# EXHIBIT D

## TREE RETENTION

1. PEG - Tree Retention Plan, November 9, 2023
2. SUF - April 2024 Audrey Estates Tree Retention and Landscape Plan Review, April 1, 2024
  3. GR3 - Geotechnical Letter (reviewing tree retention on created slopes), April 19, 2024
4. GR4 - Plan Review Letter (reviewing tree retention on created slopes), November 13, 2023

**To:** Edie Berghoff, City of Poulsbo Associate Planner  
**From:** Kevin M. McFarland, City of Poulsbo Contracted Arborist  
**Date:** 4/11/2024  
**Re:** April 2024 Audrey Estates Tree Retention and Landscape Plan Review

**TREE PROTECTION PLAN**  
**AUDREY ESTATES**  
**JWJ GROUP, LLC**  
3599 NW CARLTON ST, SUITE 201  
SILVERDALE, WA 98383

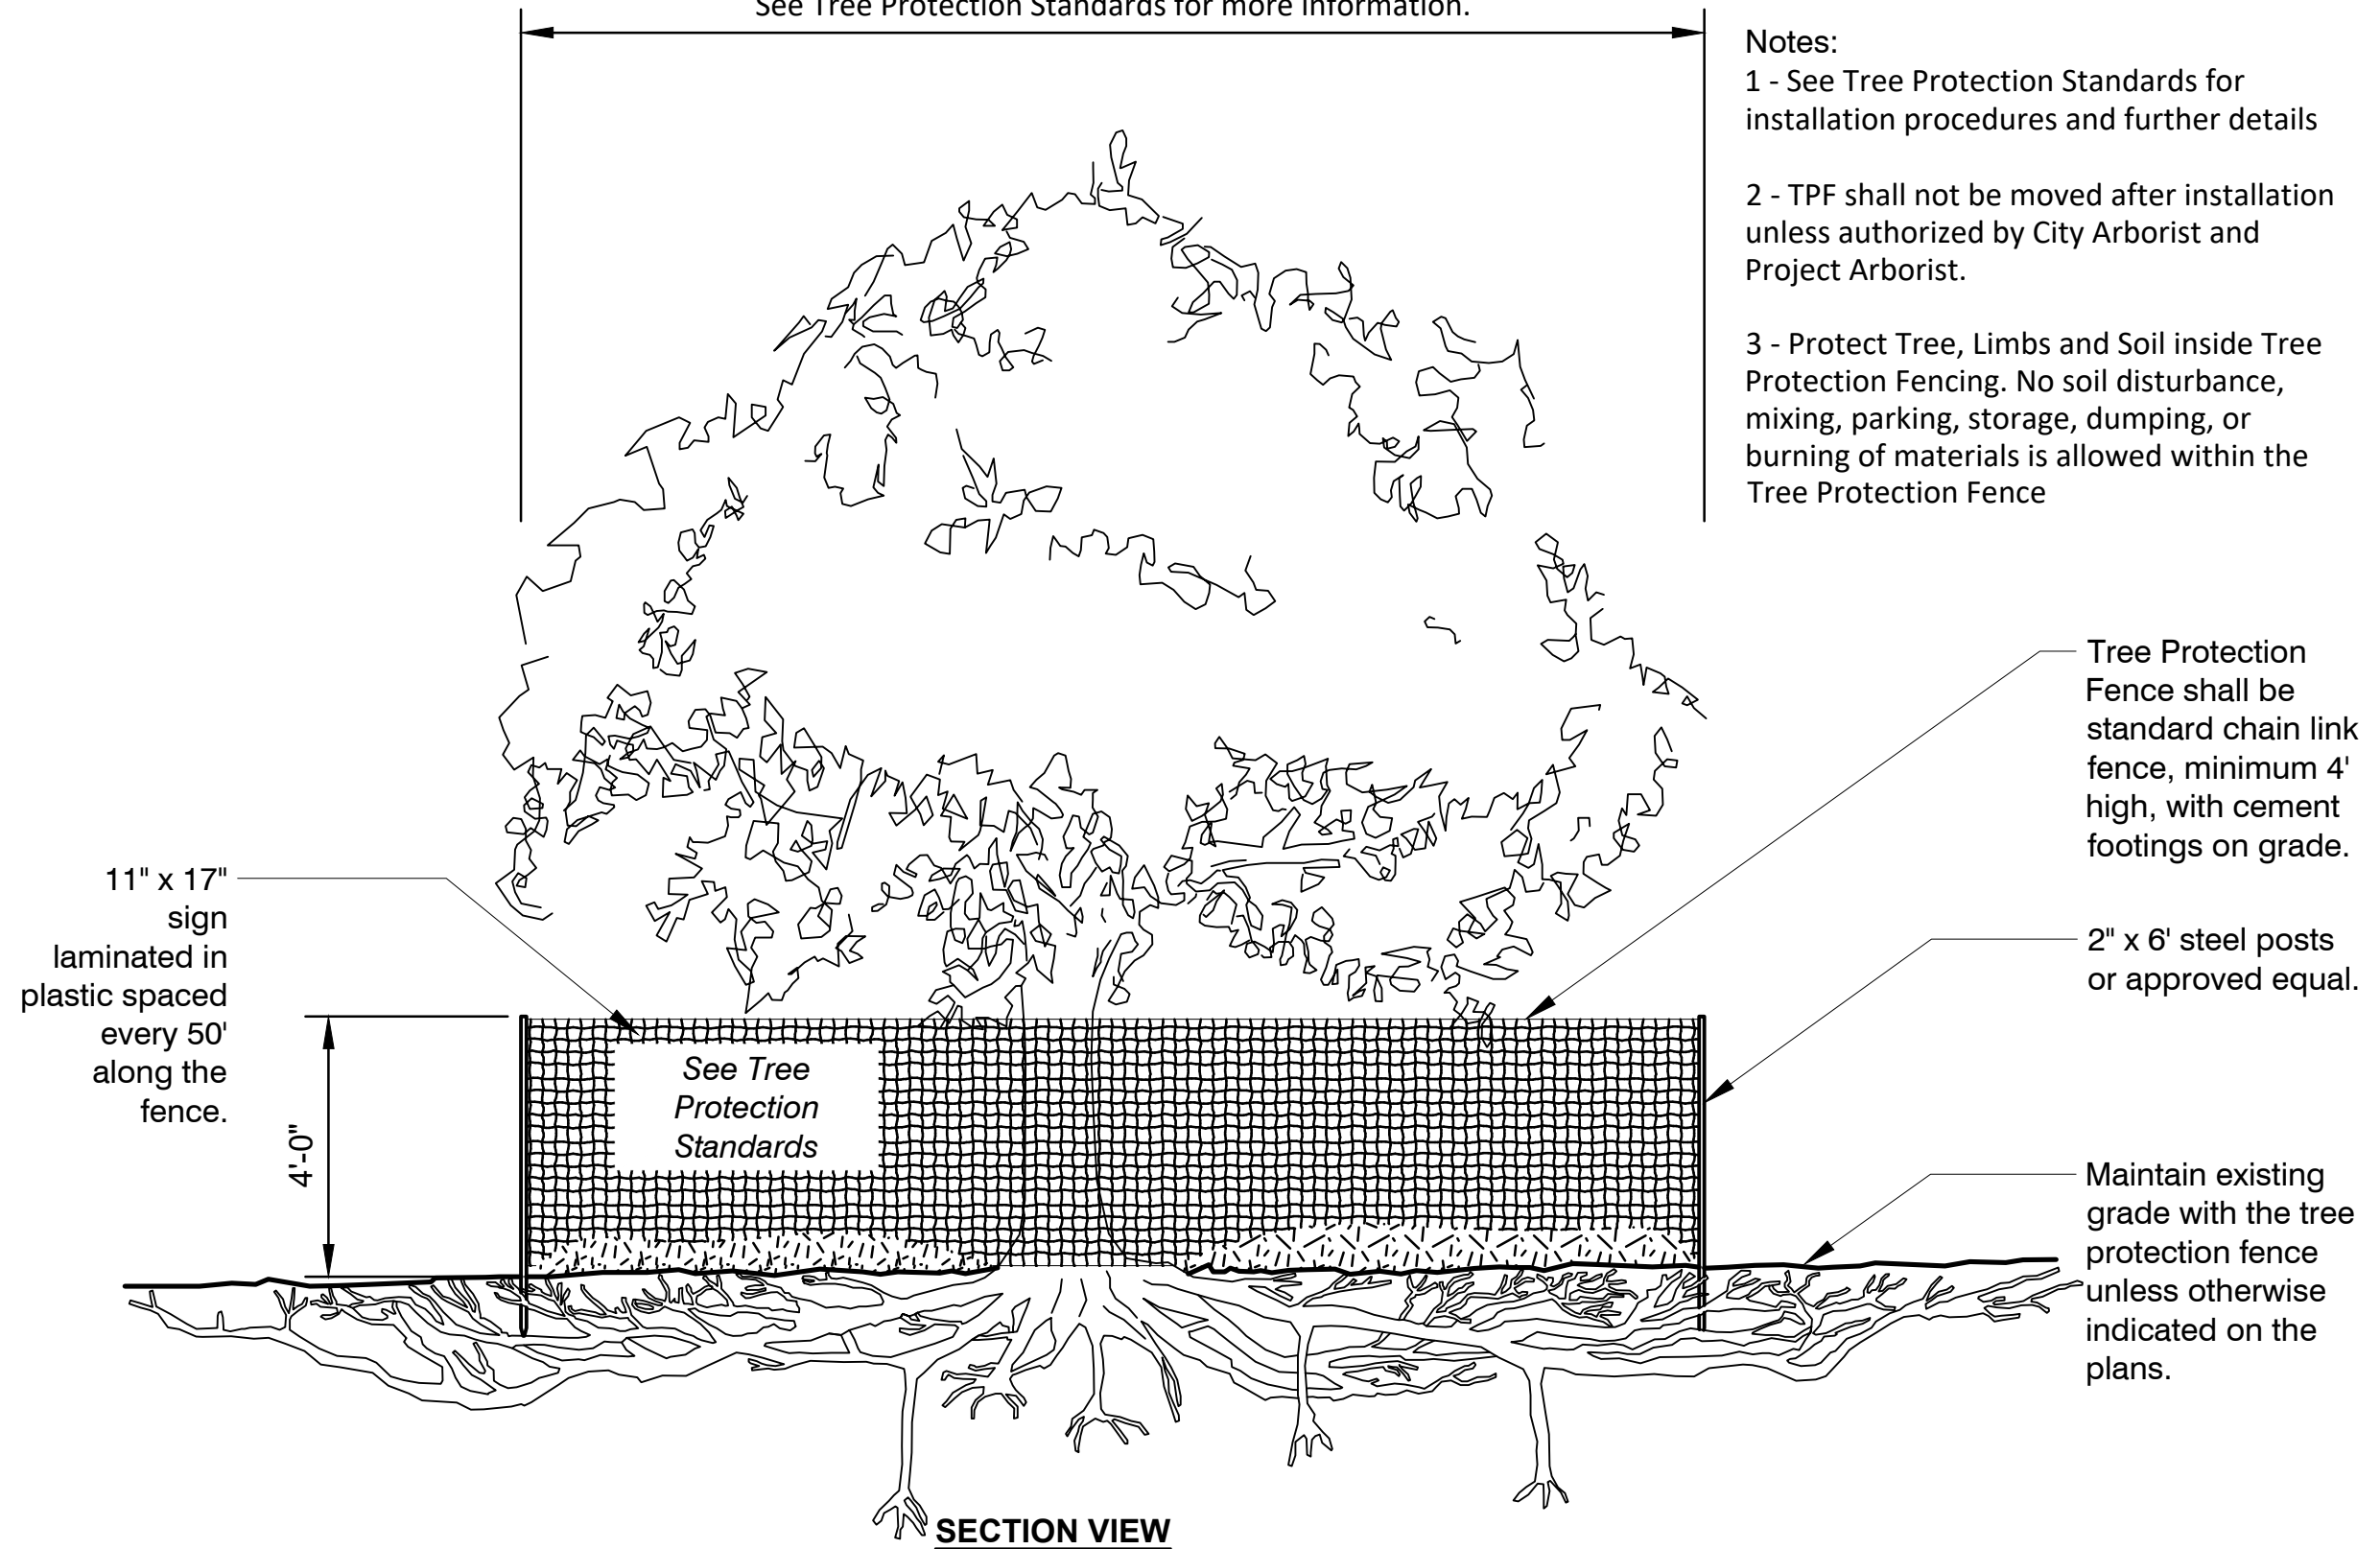
- Tree Protection: This still has not been properly addressed. There is no mention of tree protection measures along the trails or edge trees on the grading or landscape plans. The Tree Protection Plan does not address the request for tree protection fencing around trees to be retained or for those on adjacent properties. Fencing is not shown and/or specified within the legend in the Civil Plans nor the Grading/Construction Notes. This all needs to be addressed, in particular that fencing needs to be installed and inspected prior to any grading. A fencing detail shall be included as well.

SHEET	OF
<b>L2.01</b>	<b>30</b>
PROJECT NUMBER	<b>21199</b>

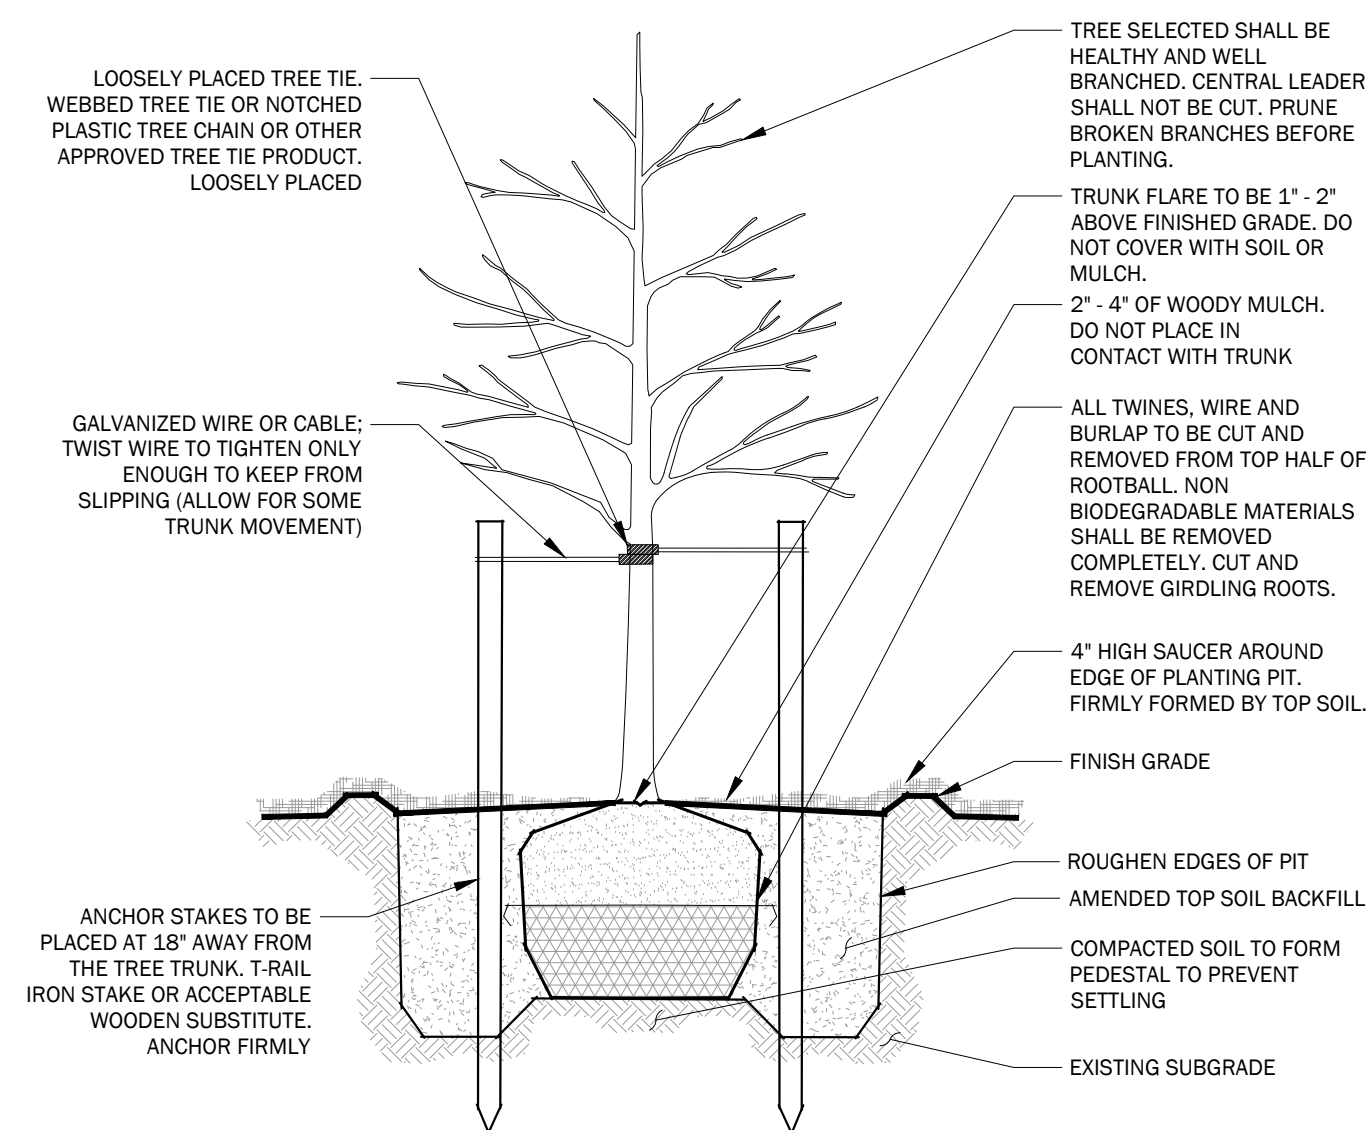
- Sheet L2.01: For plantings on the reinforced soils slopes (RSS) proposed on the east and south side of the proposed plat, the landscaping plan shows trees (Sitka Spruce) being planted on the slope east of Lots 27 to 31; trees and shrubs (Sitka Spruce, Douglas Fir, and Western Red Cedar) being planted on the slope east of Lot 36; and trees and shrubs (Sitka Spruce, Douglas Fir, and Western Red Cedar) being planted on the slope west of

- Lot 41. A “General Note” on this sheet states that only two layers of geosynthetic grid be cut to facilitate planting of the trees and planting along the RSS slopes be staggered on altering contours to limit excess cutting of the primary and secondary geogrid reinforcement. The plan also shows various trees and shrubs being planted on the cut slopes in Tract A, Tract H, and Tract I. These cut slopes will not have geogrid reinforcing.

In our November 13, 2023 revised *Geotechnical Engineering Report* we recommended that “only the top layers of geogrid may be cut to allow planting of tree balls.” This comment can be revised to include the one layer of the primary and one layer of secondary geogrid reinforcement for the RSS design, equal to the two layers of geogrid. Based on our review of the preliminary landscape sheets in the *Audrey Estates A Preliminary Plat* plan set by Core Design, it is our opinion the recommendations in our *Geotechnical Engineering Report* for the Audrey Estates plat dated November 13, 2023 and this comment response letter have been incorporated into the revised February 13, 2024 Core Design preliminary landscape plans.
